Seismic Risk and the Onshore Pipeline Portion of Sakhalin Energy Investment Company's

Sakhalin-II Phase 2 Project:

UNANSWERED QUESTIONS

January 25, 2004
(Revised Feb. 5, 2004)

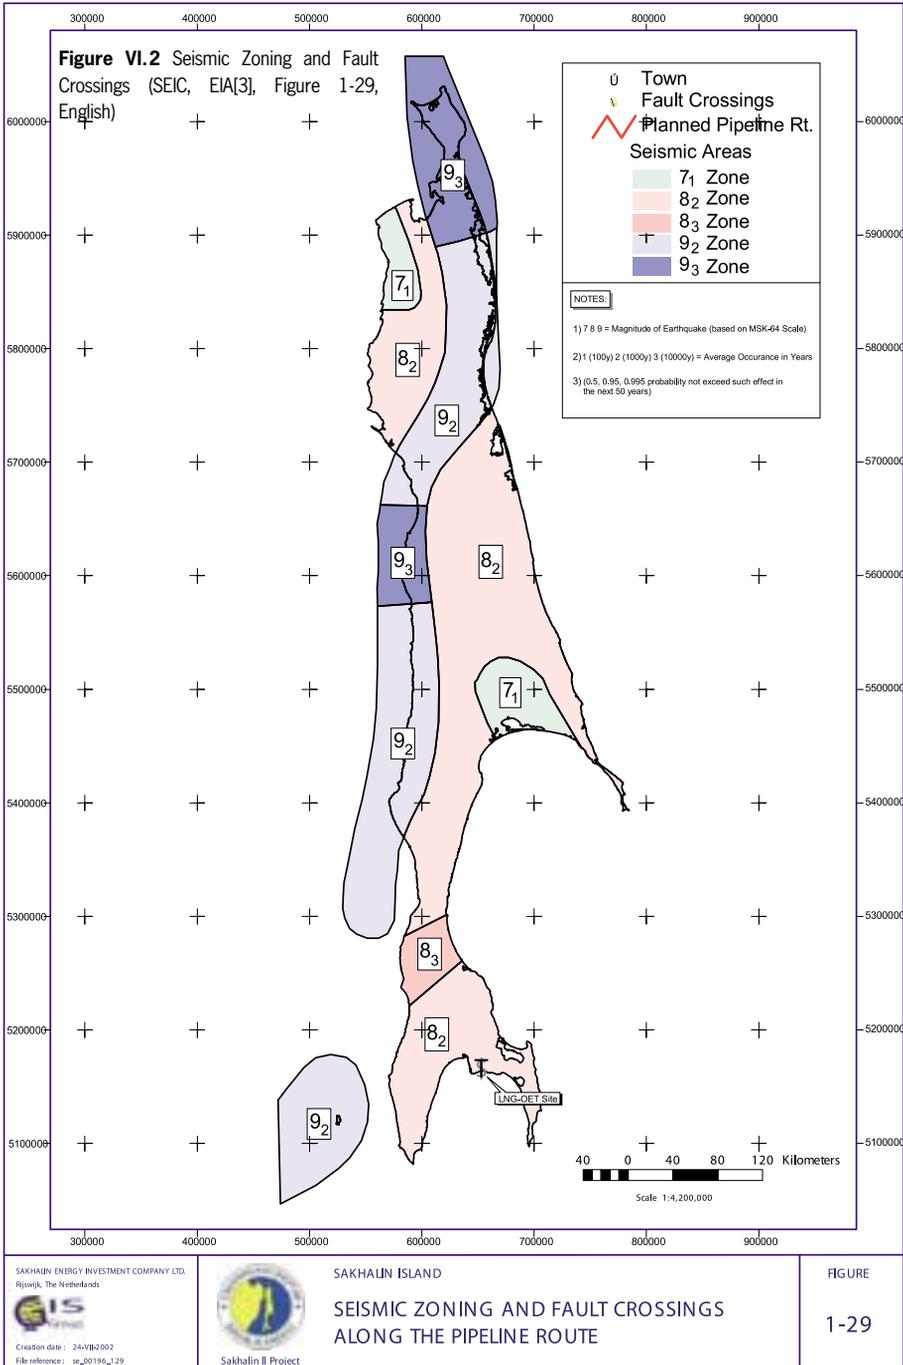
(a) The English-language version of both EIA documents published by SEIC contain maps purporting to showing the pipeline route in relation to the seismicity rating and fault crossings but neither map contains the promised information. In EIA(3), Figure 1-29 is captioned "Seismic Zoning and Fault Crossings Along the Pipeline Route."⁵⁵ (Fig. VI.2.) However, the figure does not show the pipeline route, faults or fault crossings. That information does appear in the Russian-language version of the EIA(3) map. (Fig. VI.3.) In EIA(4), SEIC states that "[t]here are 24 locations where the pipeline crosses seismic faults, as shown in Table 1.2. These are also shown in Figure 1.10 along with the seismic zones of Sakhalin Island." While Table 1.2 of EIA(4) does include a list of 24 fault crossings by kilometer post,⁵⁶ Figure 1-10 of the EIA shows neither fault crossings nor seismic zones.⁵⁷ (Fig. VI.1.)

Figure VI.5 Composite Geotechnical Zoning and Hazards Map of Argi-Pagi Area (Showing Seismic Intensity Zone Boundaries)

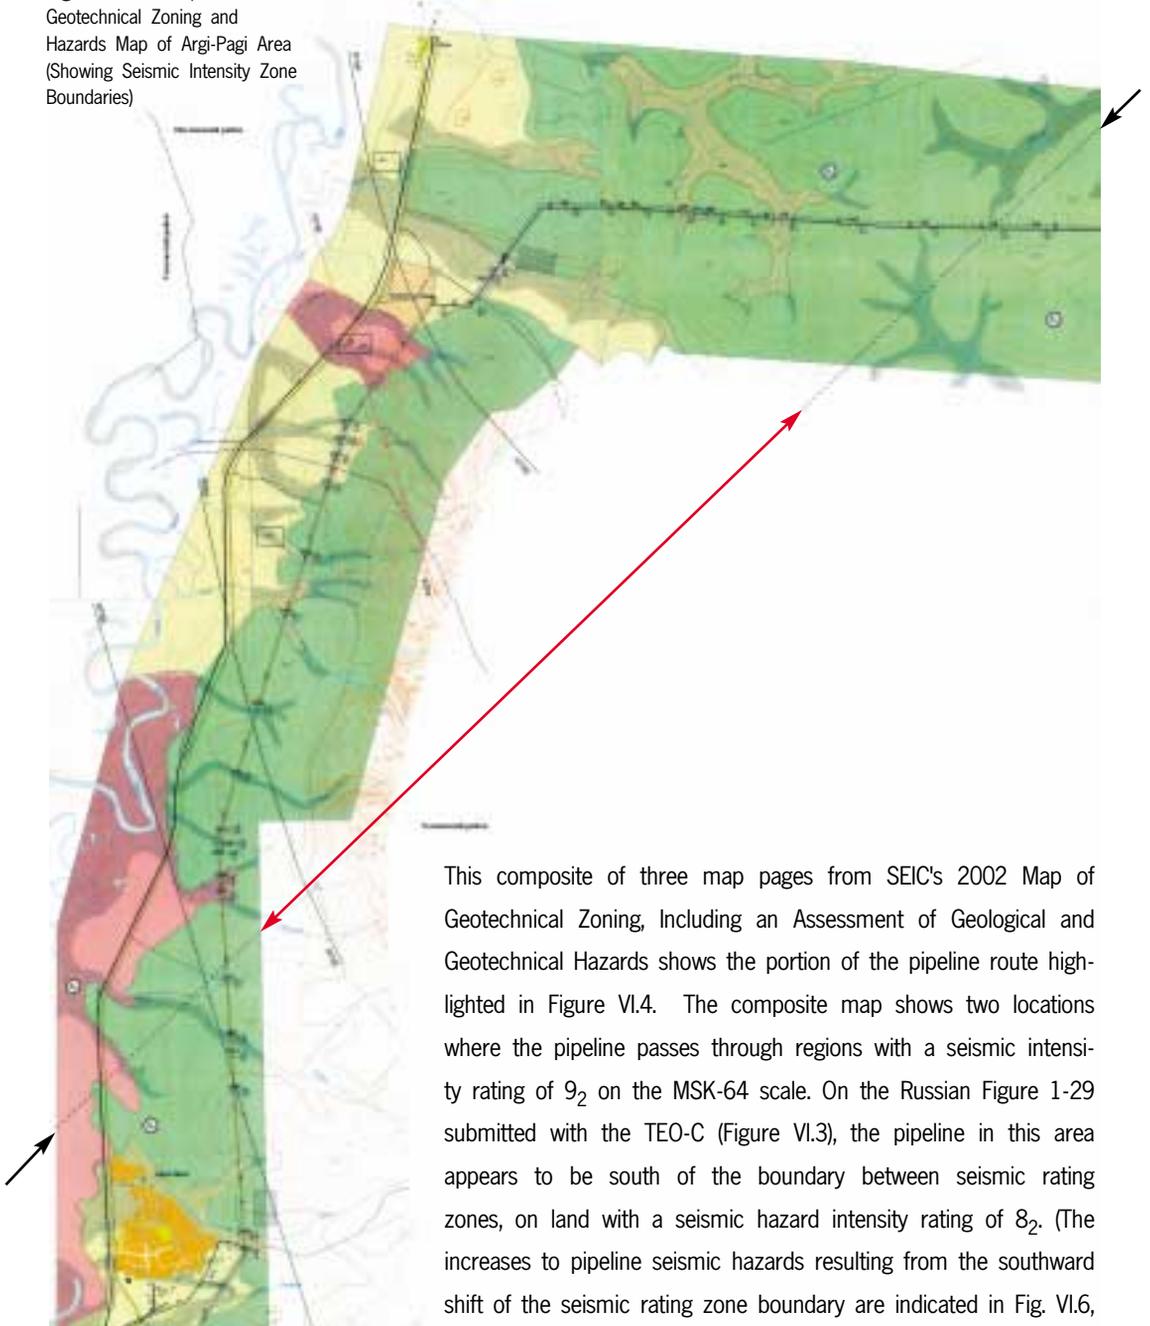
(1) The southeast limit of the 9₂ seismic intensity rating zone in the Map of Geotechnical Zoning and Hazards extends further south than shown in EIA(3) Figure 1-29; this change raises the seismic hazard rating for nearly 20 kilometers of the northern pipeline segment and a similar portion of the southern segment from 8 to 9 on the MSK scale.⁷⁰ (See Figs. VI.4, VI.5, VI.6.)
